INITIAL FIRE SAFETY INSPECTION REPORT

The Civil Engineers Woven Limited (Extension)

RSC ID: 25414

Fire Safety Inspection Report

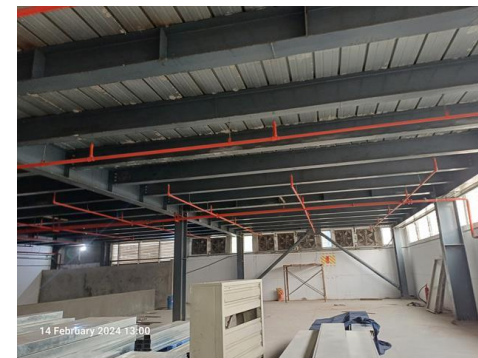
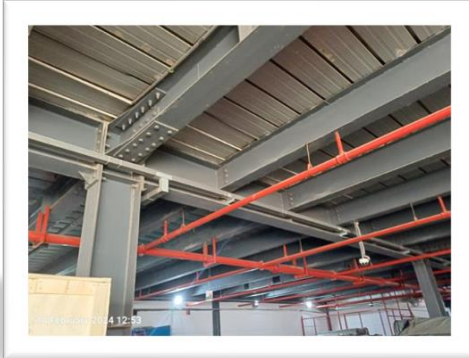
Table-1:				
SI No.	Category	Findings	Required Action	Remediation Time Frame
F-01	Fire rated Construction	The building height is more than 14 m. The main structural element of the building is constructed by steel which is non-rated and were found in exposed condition without any fire protection which is a violation of BNBC-2006.	The building is a steel structure which shall be type-I construction. So, provide required rating in the structural elements of the building. Consult with a qualified fire protection engineer. Follow BNBC 2006- Table 3.2.4, 3.1.9 and 3.3.1 as reference.	Within 6 months

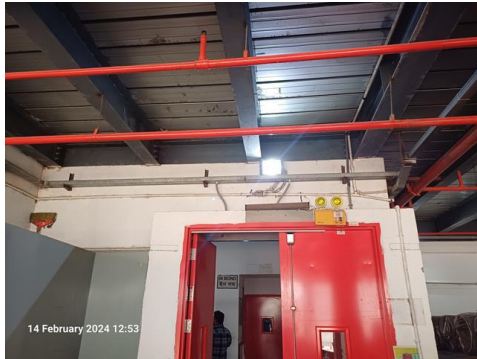
F-02	Fire Rated Construction	The exit stairs are not separated from [work areas, other spaces] on each floor by fire-rated construction. [The non-rated steel is unsealed, door holders are not functional and fire doors are not installed at all required locations, non rated glass from lift shaft]	Provide minimum 2-hr fire rated construction for buildings 4 storied or more and 1-hr for up to 3 storied. Seal all unprotected openings to separate the exit stairs from work areas and other spaces on all floor levels by 90 minutes for 2 hr. construction and 60 minutes for 1-hr construction. Ensure that the fire rated doors are self-closing and positive latching and that they are provided with fire exit (panic) hardware where serving production floors and provide vestibules to avoid direct discharge from storage to exit stair enclosure. If fire rated doors are required to be held open for functional reasons, provide automatic closing devices tied to the fire alarm system. Once fire doors are installed, every door in a stair enclosure serving more than 5 stories shall be provided with re-entry unless it meets RSC standard 6.8.3.1 If fire doors are required to be held open for functional reasons, provide automatic-closing devices tied to the fire alarm system.	Within 3 months

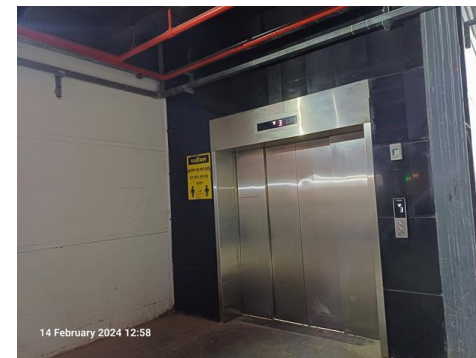
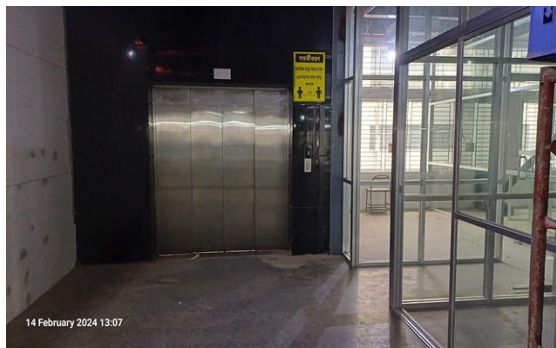
F-04	Fire Rated Construction	Elevator shafts are directly open into production floor without proper fire separation on 1st and 2nd floors.	Ensure the lift shaft is enclosed by a minimum 3-hour fire-rated wall with a minimum 2.0-hr fire-rated door. Or If not possible anyway provide a minimum 2-hr fire-rated elevator shaft with a listed fire-rated lift landing door to separate from each floor level.	Within 3 Months
------	-------------------------	---	--	-----------------

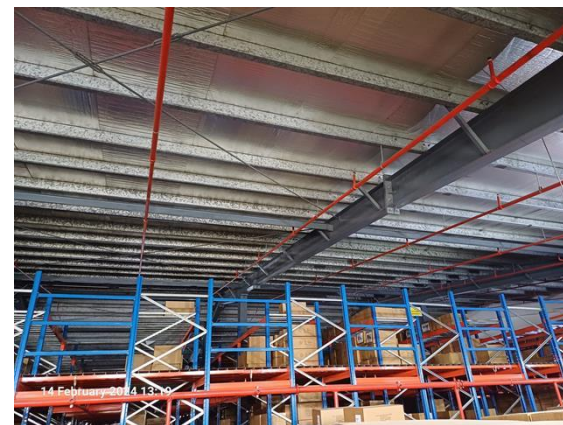
F-06	Fire Rated Construction	The mezzanine on the 2nd floor was found to be more than one-third of the floor area.	According to BNBC 2006, Chapter 1, Part 3, 1.12.6: The total area of mezzanine floors in a building shall not exceed one-third the plinth area of the building. The area of the mezzanine floors shall be included in calculating the FAR. Also, follow the in accordance with The RSC Technical Guidelines (Standard) 6 Part 6 Means of Egress.	Within 3 months
------	-------------------------	---	---	-----------------
